### ADDENDUM No. 3 TO THE CONTRACT DOCUMENTS

Project: <u>City of Unalaska Port Lighting Upgrades</u>

Addendum Issue Date: April 14, 2014

Electrical Legend and Fixture Schedule, Sheet E1 (Rev. 1)

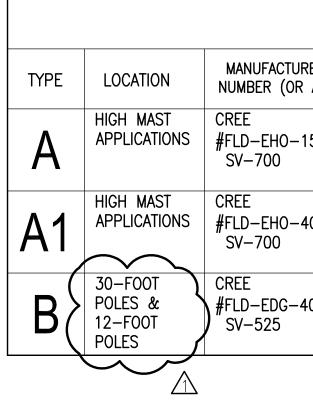
- 3.1 In the LIGHT FIXTURE SCHEDULE add "& 12-FOOT POLES" in the LOCATION box for TYPE B fixtures, and add "12'-0" A.F.G." in the MOUNTING/HEIGHT box for TYPE B fixtures.
- 3.2 A revised version of this drawing is attached to this addendum.
